C15-2011-0097
TR-0218060702
ROW-10634192

CITY OF AUSTIN
APPLICATION TO BOARD OF ADJUSTMENT
GENERAL VARIANCE/PARKING VARIANCE

STREET ADDRESS: 3803 Duval ST. Austin TX 78751
LEGAL DESCRIPTION: Subdivision - Oaklawn Addn

PROPOSED

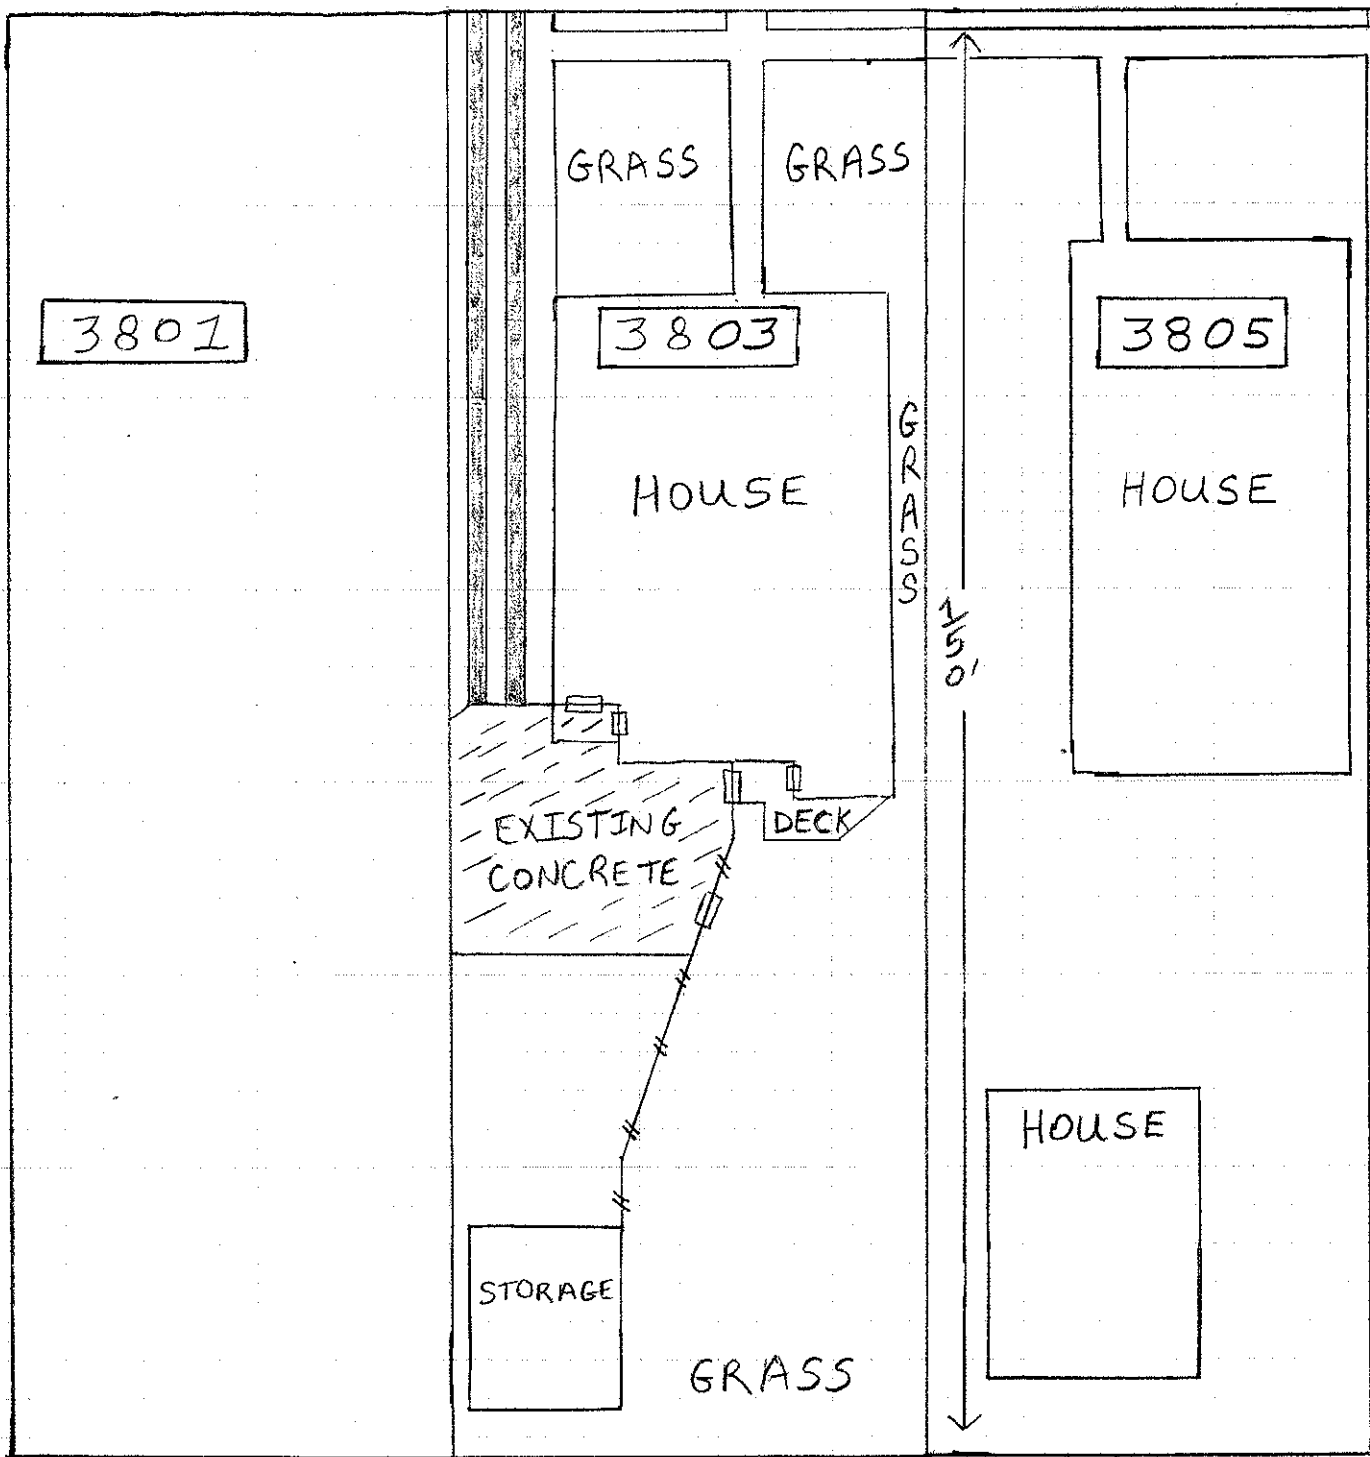
8-12-2011
This configuration
for parking is acceptable
for transportation purposes

David - Sorry for the late response. Attached is a signed copy of your proposed parking concept.
